Model: DDP70/92/184		Date: 30-Jan-06	No.: MG150001
Modified Article: Parts Catalog Correction		Prepared by: Y.Minakawa	
From: 2nd Tech. Support Sec. Service Support Dept.			
Reason for Modification:	<input checked="" type="checkbox"/> Parts catalog correction <input type="checkbox"/> Vendor change <input type="checkbox"/> Other <input type="checkbox"/> To facilitate assembly <input type="checkbox"/> To improve reliability <input type="checkbox"/> To meet standards <input type="checkbox"/> Part standardization <input type="checkbox"/> Product Safety ()

Model: DDP184		Date: 30-Jan-06	No.: MG150002
Modified Article: Parts Catalog Correction		Prepared by: Y.Minakawa	
From: 2nd Tech. Support Sec. Service Support Dept.			
Reason for Modification:	<input checked="" type="checkbox"/> Parts catalog correction <input type="checkbox"/> Vendor change <input type="checkbox"/> Other <input type="checkbox"/> To facilitate assembly <input type="checkbox"/> To improve reliability <input type="checkbox"/> To meet standards <input type="checkbox"/> Part standardization <input type="checkbox"/> Product Safety ()

DDP70/92

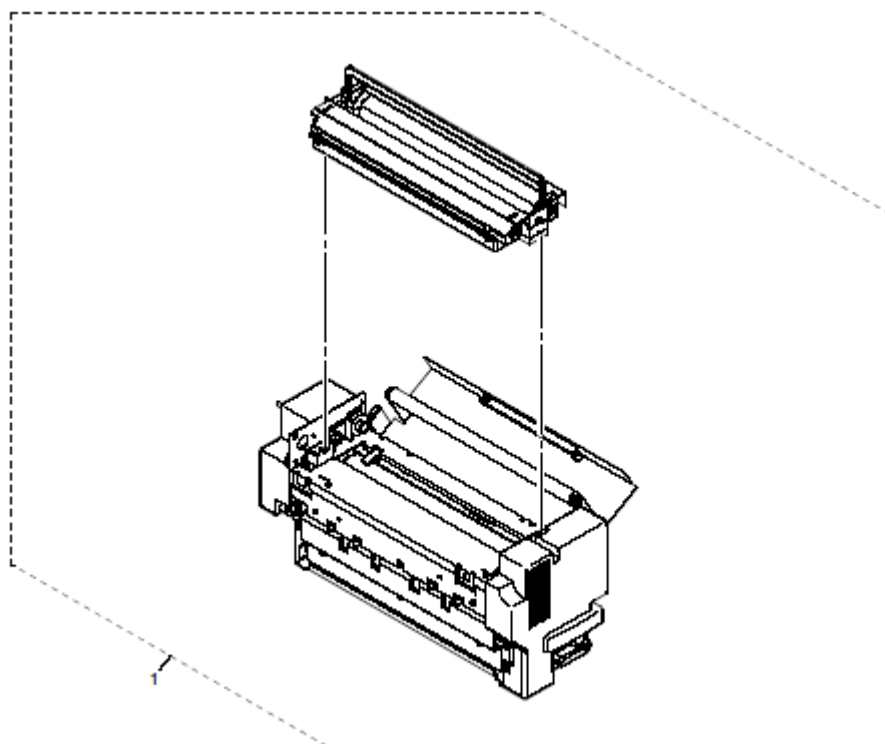
Change:

- 1) The Fuser Cleaning Web was deleted from Service Parts.
- 2) The description for G1521130 was corrected.

Reason:

- 1) The part is user-replaceable.
- 2) The description in the Parts Catalog was incorrect.

Illustration change
Pg.6

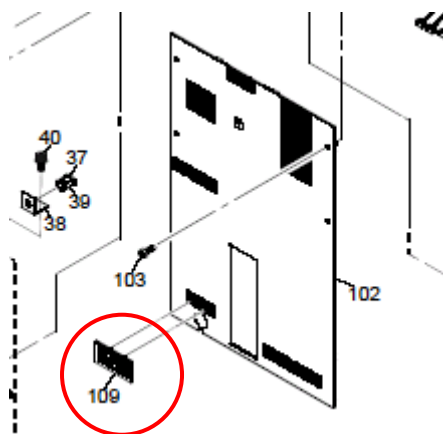
Change: The PS Air Filter was added to the printer rear cover.

Reason: To further protect the inside of the printer from dust.

Illustration change

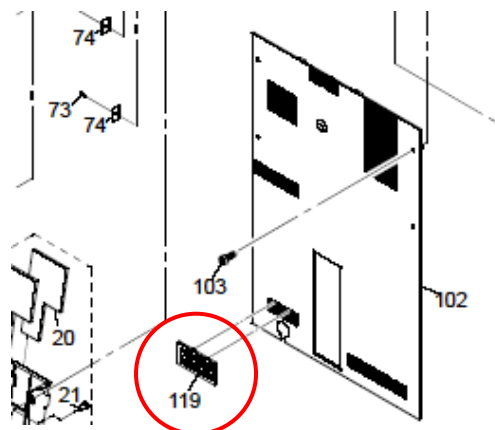
Change: The PS Air Filter was added to the printer rear cover.

Reason: To further protect the inside of the printer from dust.

Illustration change

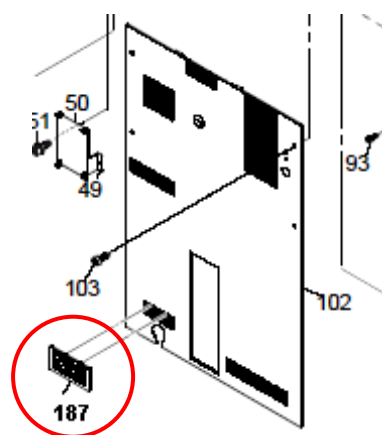
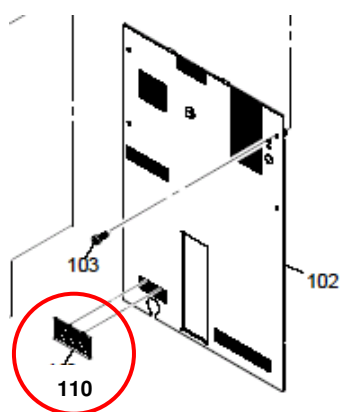
Change: The PS Air Filter was added to the printer rear cover.

Reason: To further protect the inside of the printer from dust.

Pg. 8(10)

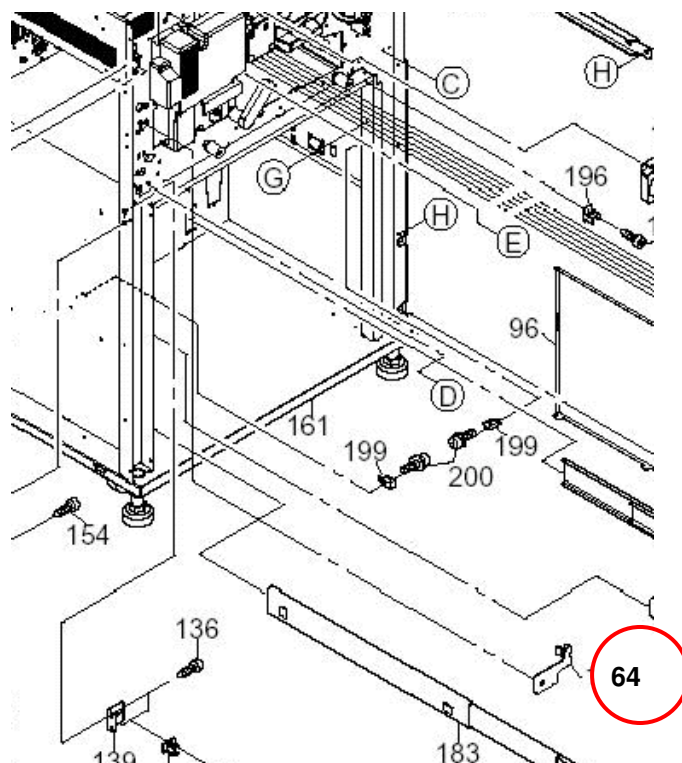
Change: The part in the table was added to the Mecha Frame Ass'y.

Reason: To ensure that the Flip Gate Assembly is not damaged when the Fuser Unit is inserted in the printer.

Note: This can happen if the exit guide of the fuser unit is not closed when the Fuser Unit is inserted into the printer.

Pg. 8

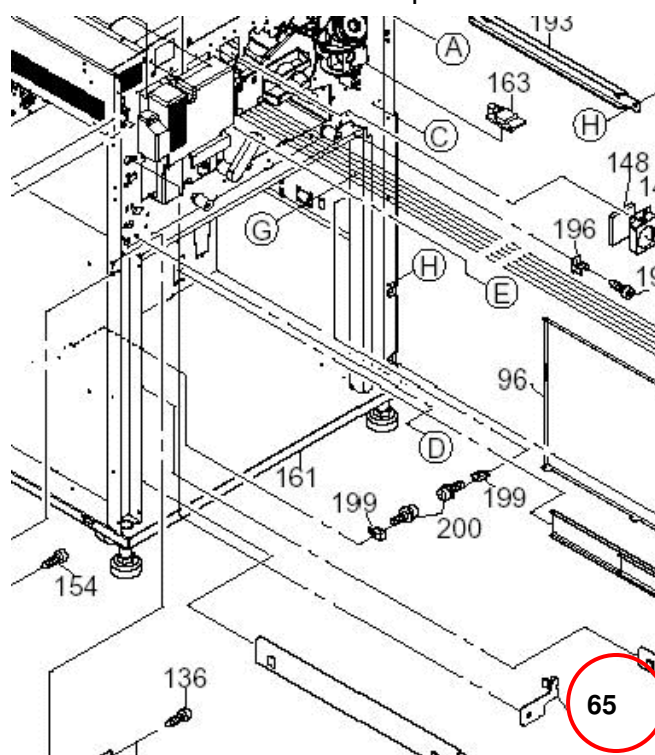
Change: The part in the table was added to the Mecha Frame Ass'y.

Reason: To ensure that the Flip Gate Assembly is not damaged when the Fuser Unit is inserted in the printer.

Note: This can happen if the exit guide of the fuser unit is not closed when the Fuser Unit is inserted into the printer.

Pg. 10

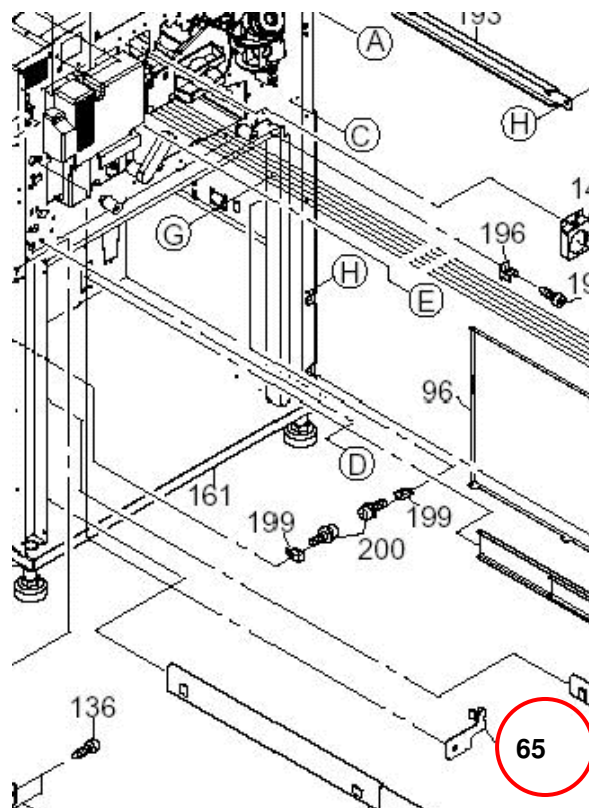
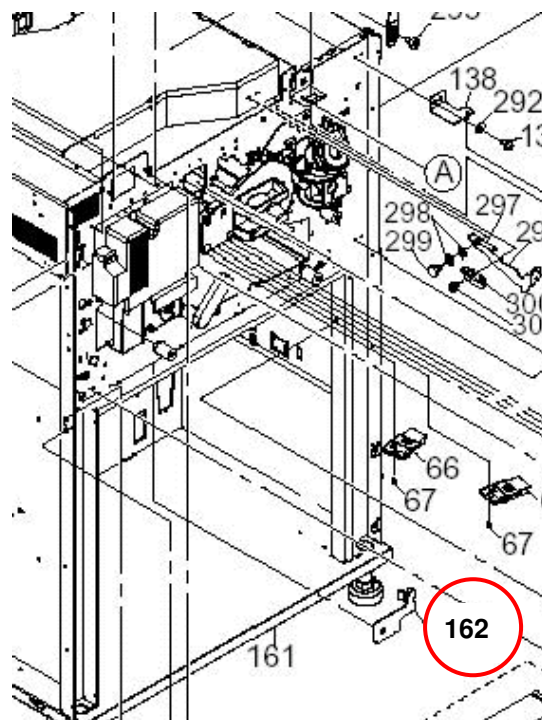
Change: The part in the table was added to the Mecha Frame Ass'y.

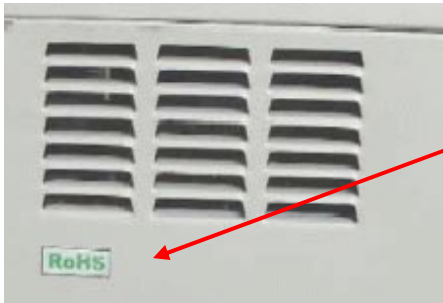
Note: The “RoHS” label shown below was added to the side cover of RoHS compliant finishers.

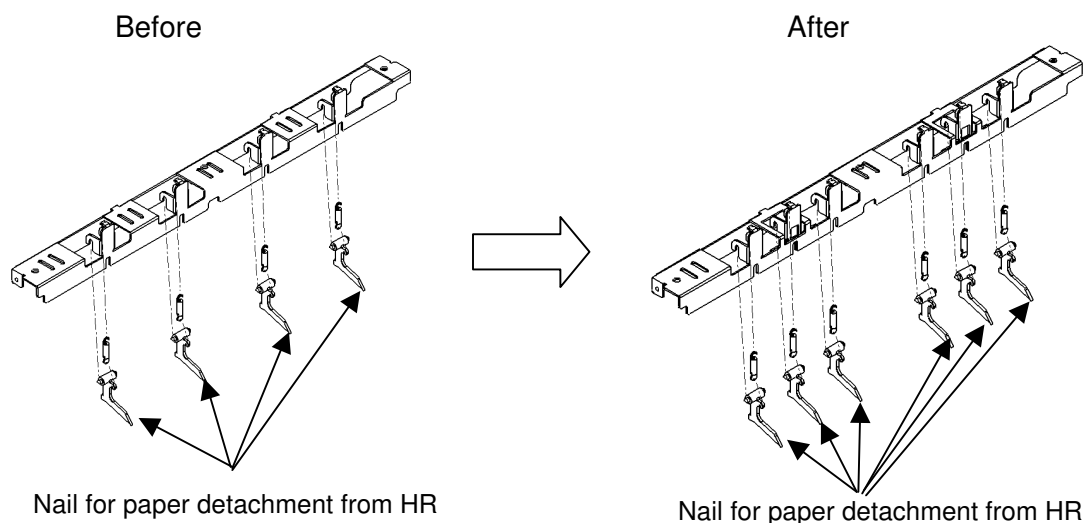
Change: Two more detachment nails were added to the fuser unit of the rear engine.

- 1) To improve the paper detachment from the Heat Roller
- 2) To ensure fuser jams do not occur in duplex mode with legal paper.

Before Change

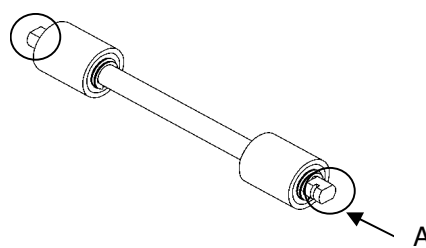
Change: The shape of Pressure Roller Ass'y in the Relay Unit was changed.

Reason: To ensure that the shaft of the Pressure Roller Ass'y does not touch the Paper Guide.

Pg. 28

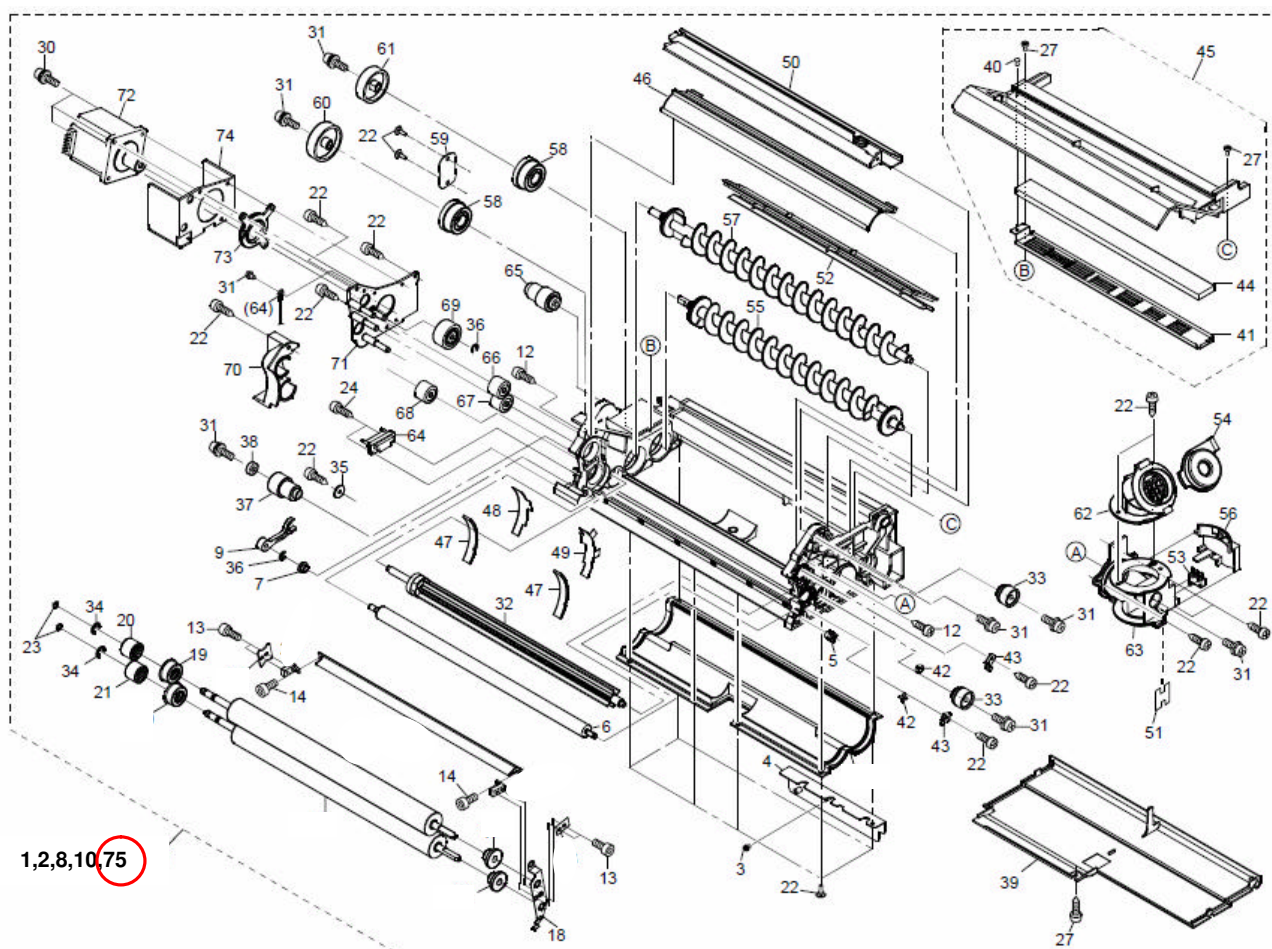
Change: The part in the table was added for the Color kit DDP184 Reflex Blue.

Old part

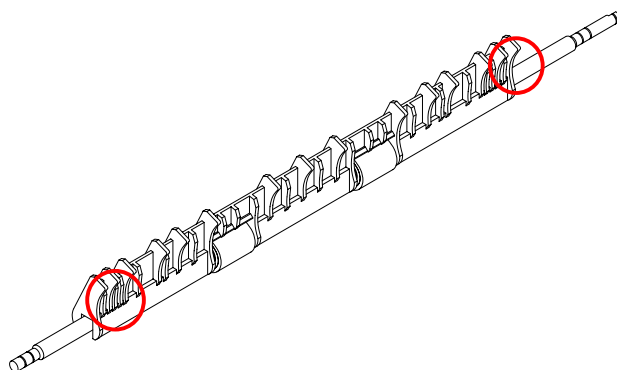
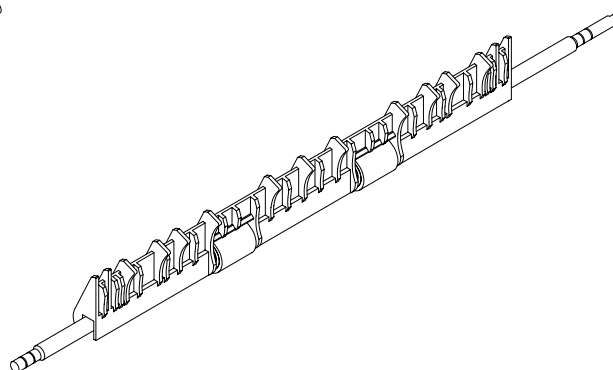
Change: Four ribs were removed from the SB Gate Ass'y (rear engine).

Reason: To further ensure paper jams do not occur.

Note: Sometimes, these four ribs can wear out and cause paper jams.

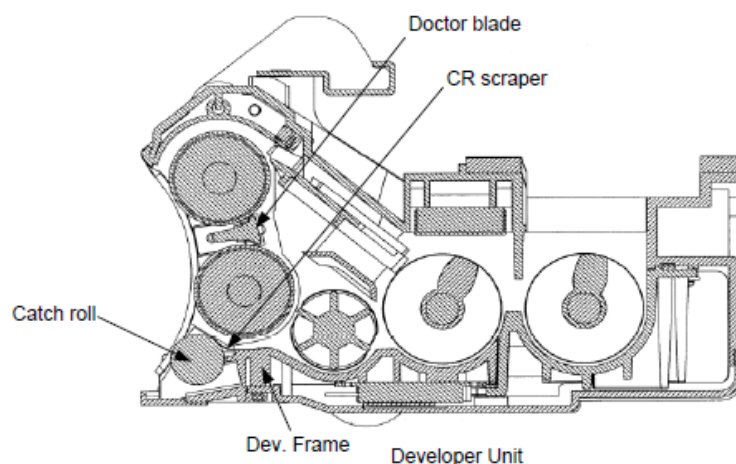
- The material of the doctor blade for the development unit was changed (SiC and Ni-P was added to the surface of the doctor blade).
- The double-sided tape was changed to a stronger type.

- To increase the durability of the doctor blade and further ensure the developer mixture does not leak out from the development unit.
- To further ensure the CR Scraper and development unit frame are secured more strongly.

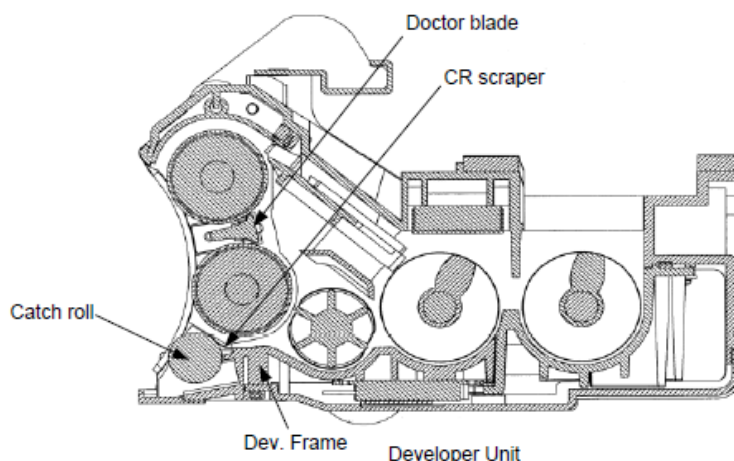
- The material of the doctor blade for the development unit was changed (SiC and Ni-P was added to the surface of the doctor blade).
- The double-sided tape was changed to a stronger type.

- To increase the durability of the doctor blade and further ensure the developer mixture does not leak out from the development unit.
- To further ensure the CR Scraper and development unit frame are secured more strongly.

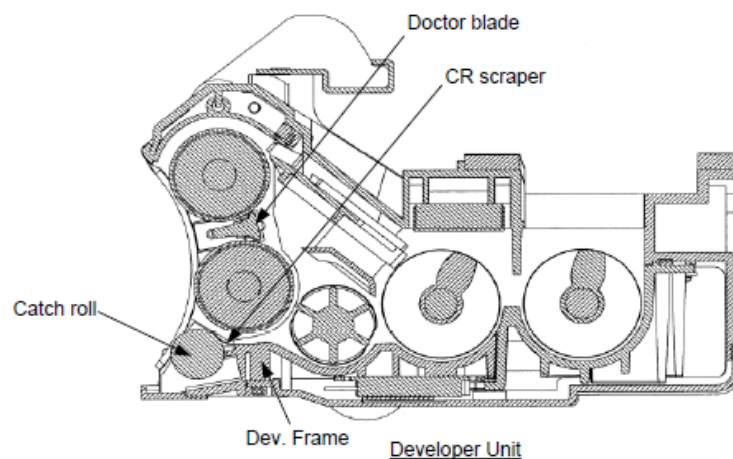
1. The material of the doctor blade for the development unit was changed (SiC and Ni-P was added to the surface of the doctor blade).
2. The double-sided tape was changed to a stronger type.

Pg. 30

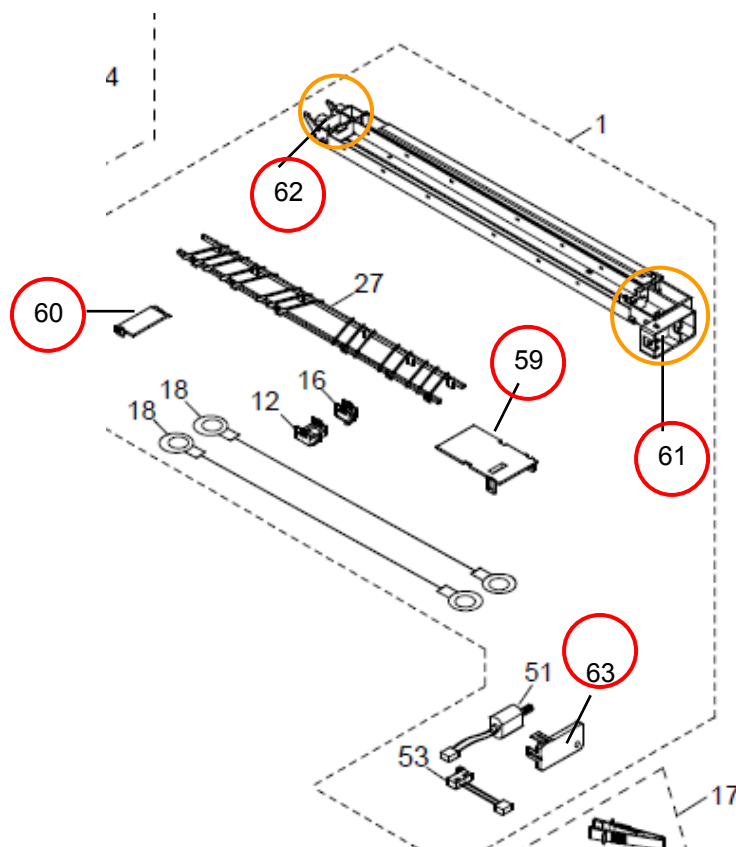
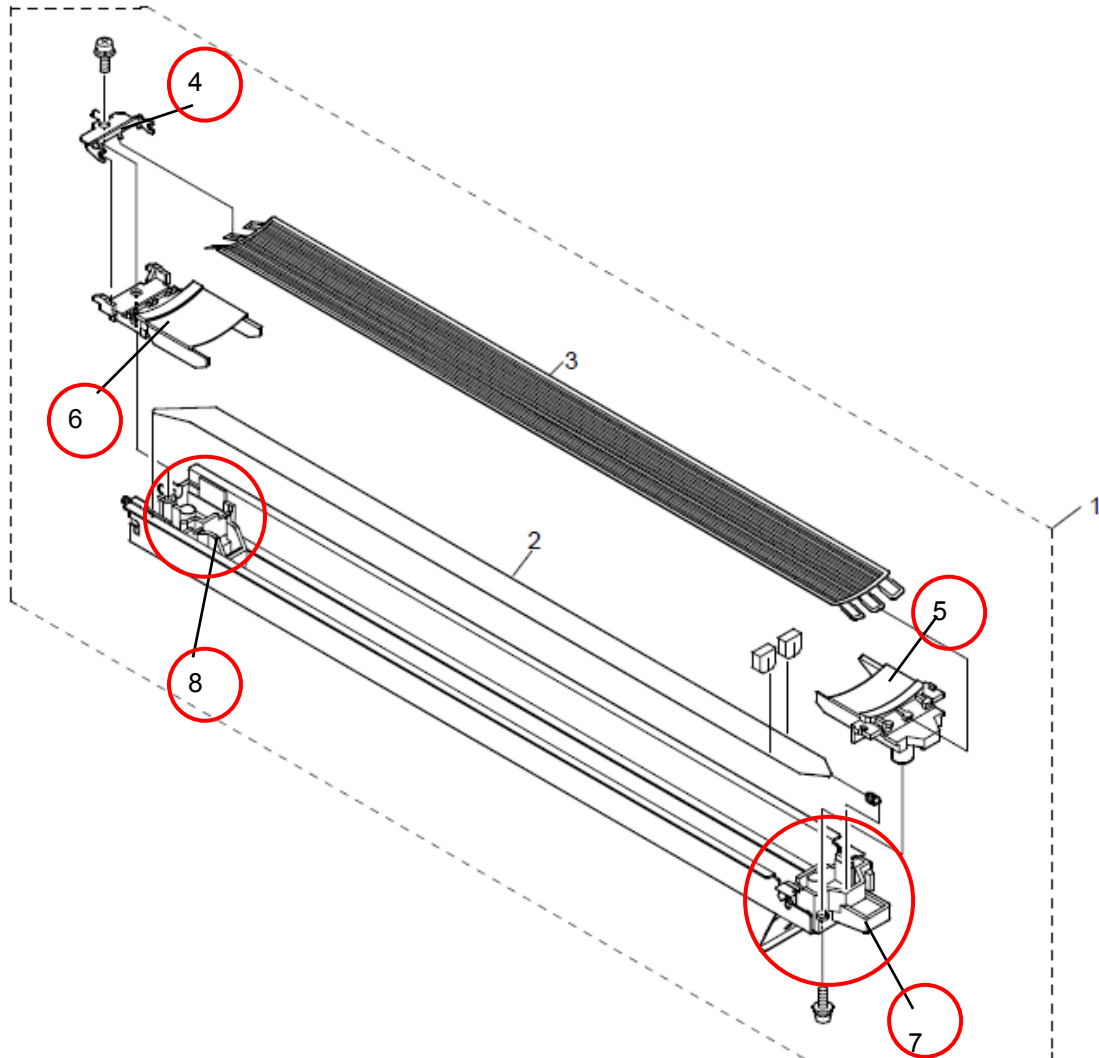
Change: The individual parts of the Corotron Ass'y and the Charger Ass'y were registered as service parts.

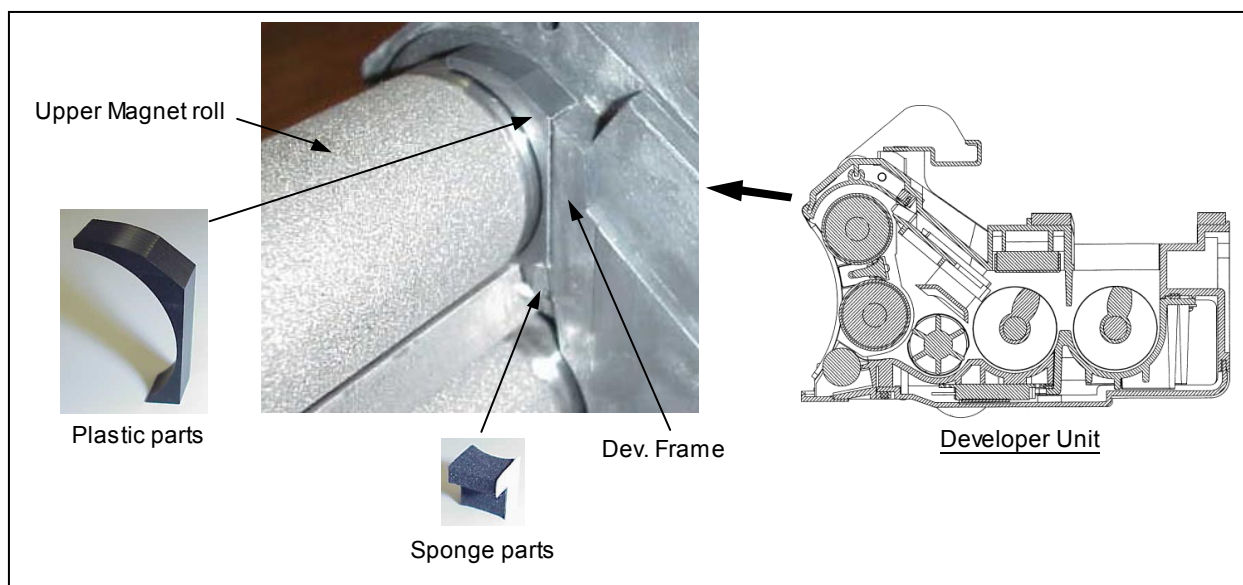
Plastic parts and sponge parts are attached between the Dev.frame and Upper magnet roll.
Applied to both ends of the Upper magnet roll.

To prevent developer mixture leaks.

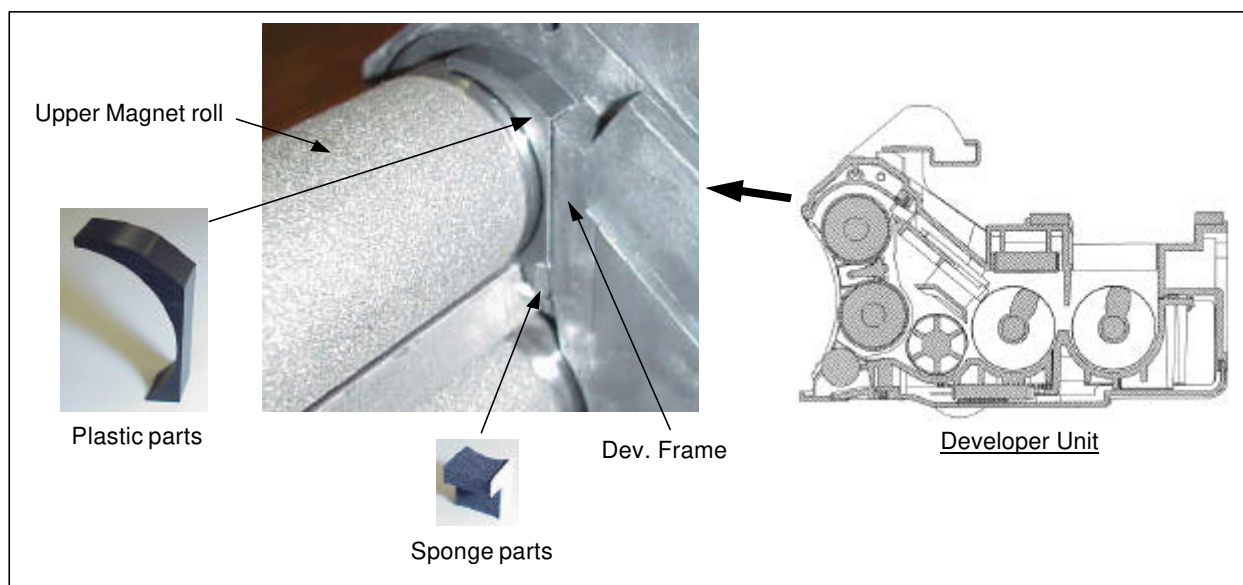
Plastic parts and sponge parts are attached between the Dev.frame and Upper magnet roll.
Applied to both ends of the Upper magnet roll.

To prevent developer mixture leaks.
